Submissions Report

NEVERTIRE SOLAR FARM

APRIL 2017

Figure 2-1 Updated proposed layout

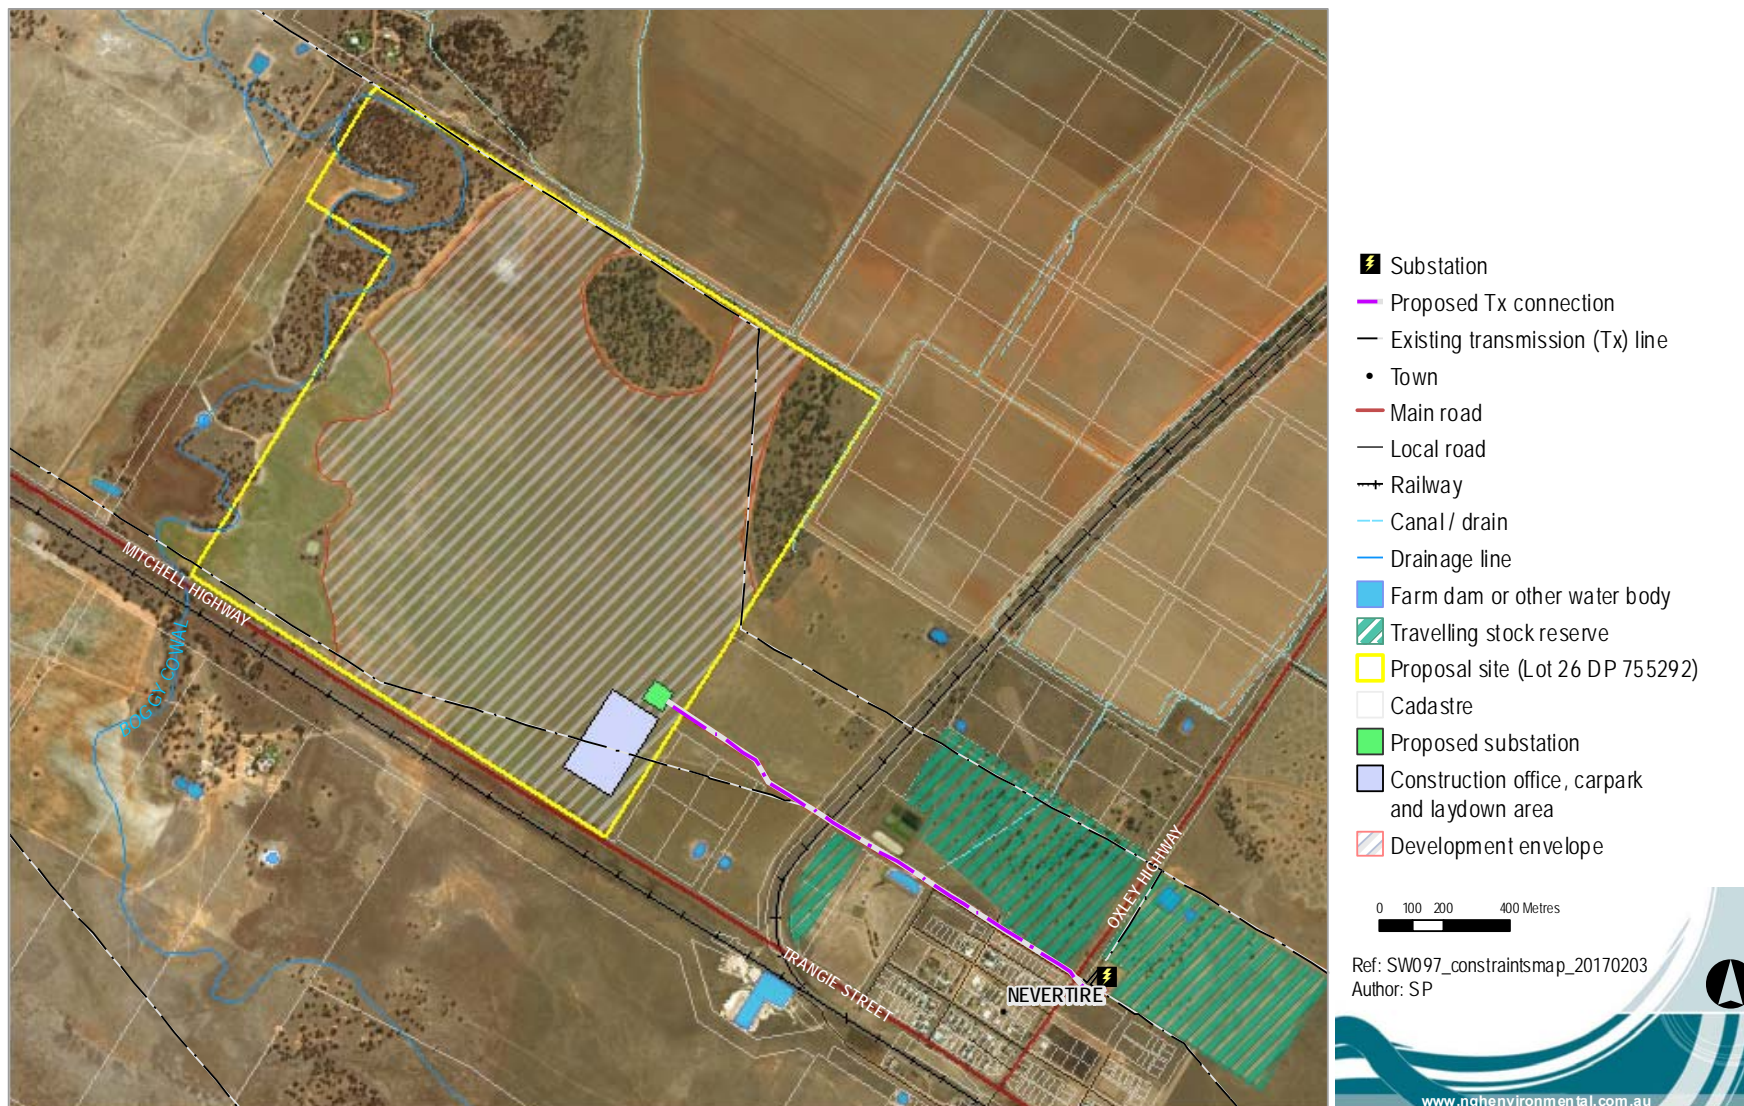
The following minor changes have been made to the proposal. These changes constitute a reduction in the area of the proposed development, for the purpose of reducing impacts on native vegetation and areas that may contain threatened species habitat.

The Biodiversity Assessment Report (BAR) for the proposal and subsequent OEH correspondence identified that the small patch of woodland vegetation surrounding the dam and the inundation area adjacent to Boggy Cowal could potentially provide suitable habitat for threatened species including the Koala and Sloane’s Froglet, respectively. Rather than undertake further targeted surveys, the proposal now avoids these areas.

EIS description	New description
The one dam onsite would be decommissioned and may be filled in.	The dam onsite and vegetation surrounding the dam would not be impacted by the proposal. The solar array and associated infrastructure would avoid the dam and adjacent trees. Refer to updated infrastructure layout, Figure 2-1.
Solar array infrastructure would be developed to within 40m of the mapped Boggy Cowal centre line.	The solar array would now avoid the identified inundation area and potential Sloane’s Froglet habitat located in the south western portion of the site, adjacent to Boggy Cowal. The reduced solar array area is now approximately 177 ha. Refer to updated infrastructure layout, Figure 2-1.

Figure 4.1 Flow Distribution 1955 Flood

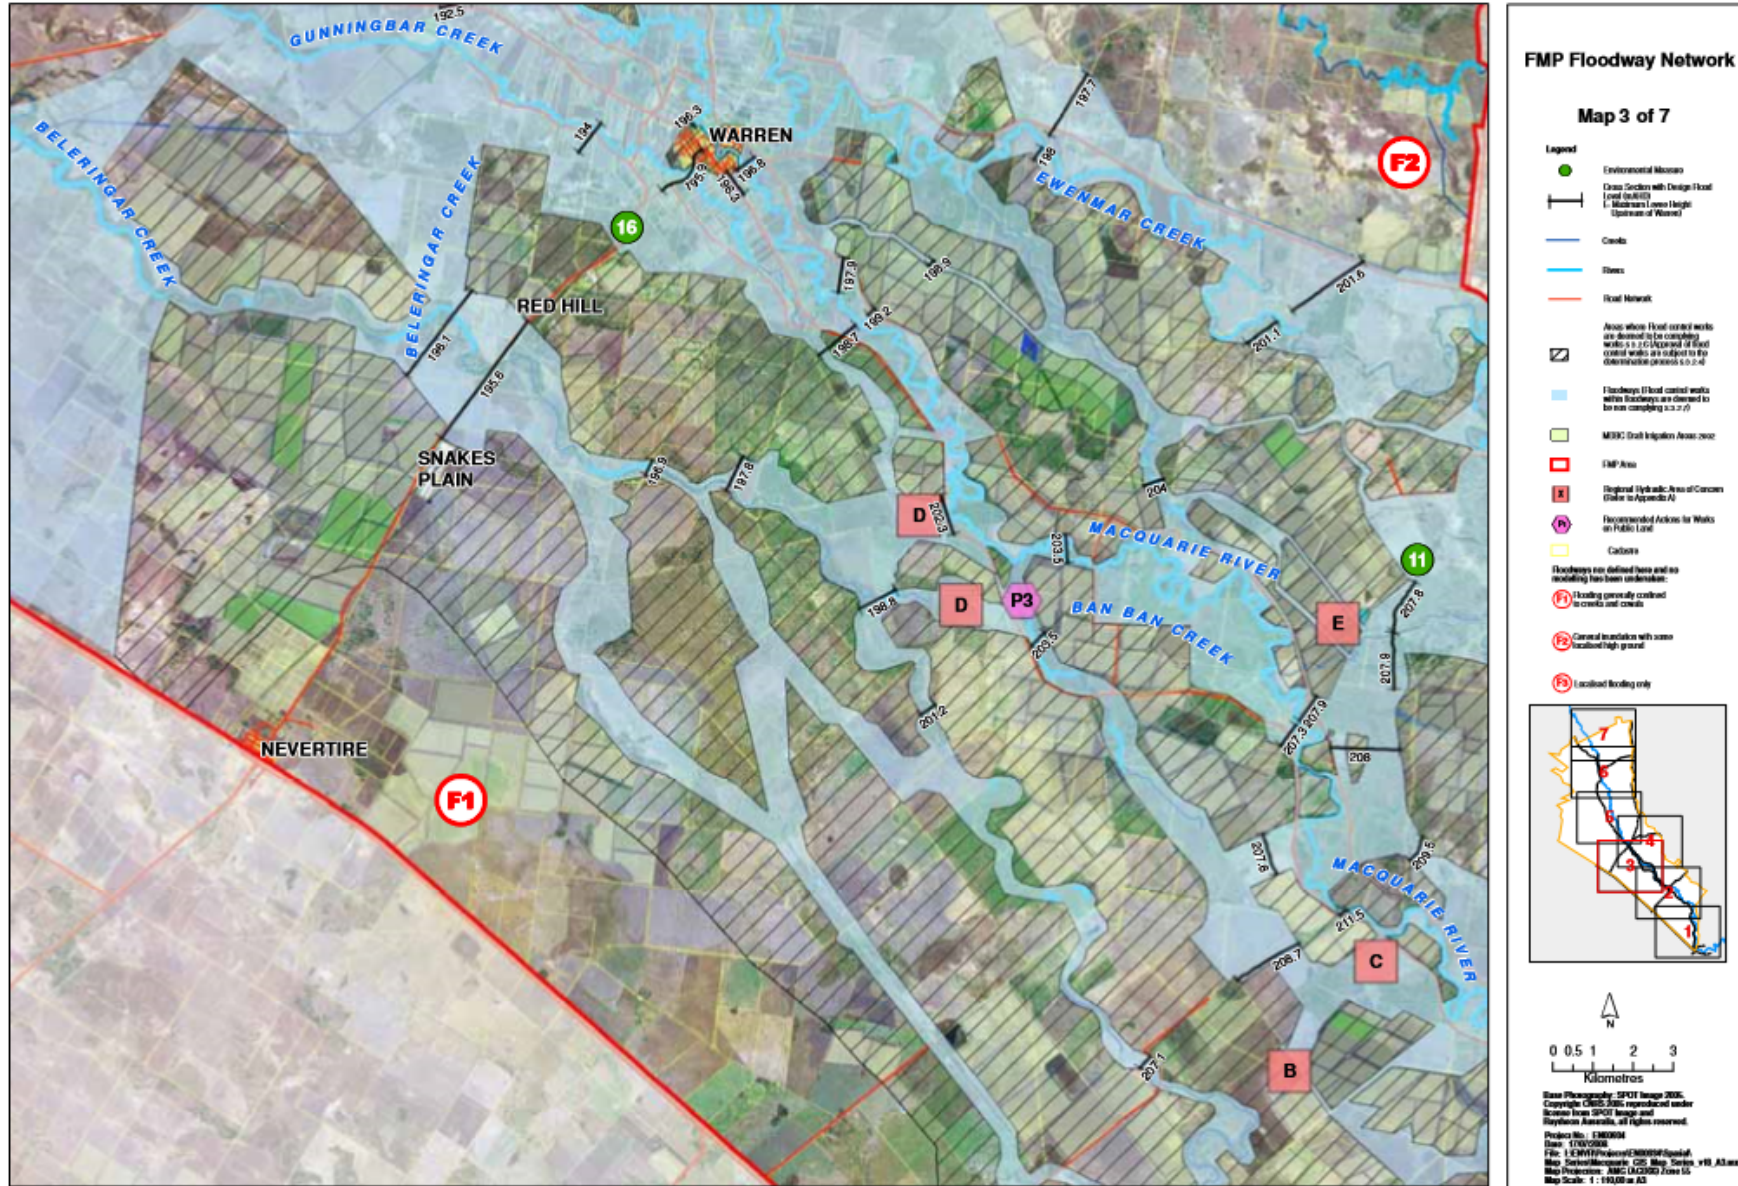
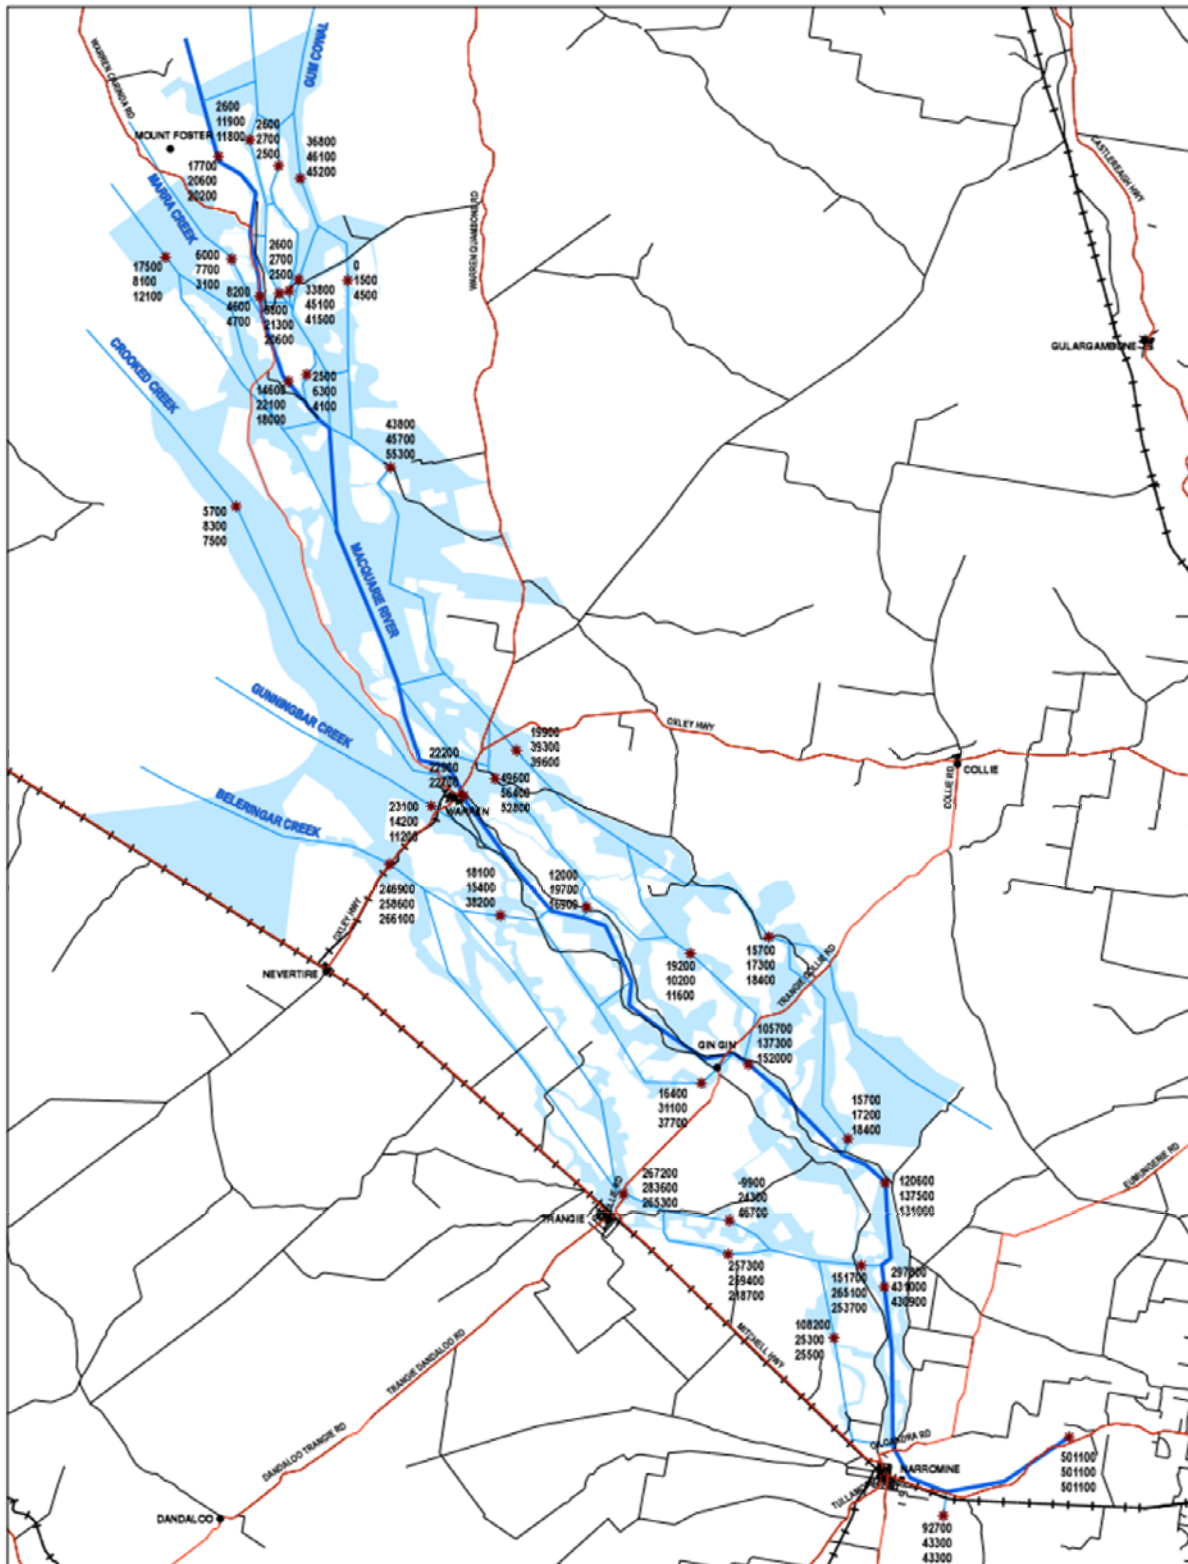
Issue	Proponent's response
Flooding	<p>NSW Department of Primary Industries commented the proponent should undertake an assessment of the potential impacts on flooding on neighboring properties due to the buildings and the solar array infrastructure.</p> <p>The EIS indicated that no Flood Prone Land mapping for the site had been identified. Since that time a flood study and flood mapping has been identified (Macquarie River Narromine to Oxley Station, Floodplain Management Plan, Department of Environment and Climate Change, 2008). The study assigned the 1955 and 1990 floods average recurrence interval of 200 and 65 years respectively. The resultant flood maps indicate that the site is above a 1 in 200 year flood level (see Appendix B) and would also not have been inundated according to the 1990 and 2000 flood flow distribution. Therefore, the site is confirmed to be not subject to river flooding. The EIS indicates the site is expected to be slow draining due to heavy soils. However, the proposal does not involve any extensive earthworks or landform reshaping and therefore the onsite hydrology would not be altered during construction or decommissioning.</p> <p>The project will not change the onsite hydrology and the site is confirmed to not be flood effected, therefore there will be no flood impact on neighbouring properties.</p> <p>As flooding is no longer considered a substantive issue, one mitigation measure listed within the EIS has been deleted:</p> <ul style="list-style-type: none"> • <i>A flood risk contingency plan would be prepared prior to construction and is to be implemented during construction, operation and decommission. The plan would:</i> <ul style="list-style-type: none"> ○ <i>Detail who would be responsible for monitoring the flood threat and how this is to be done.</i> ○ <i>A process for removing any necessary equipment and materials offsite and out of flood risk areas.</i> ○ <i>Consideration of site access in the event that some tracks become flooded.</i> ○ <i>Establishment of an evacuation point.</i>
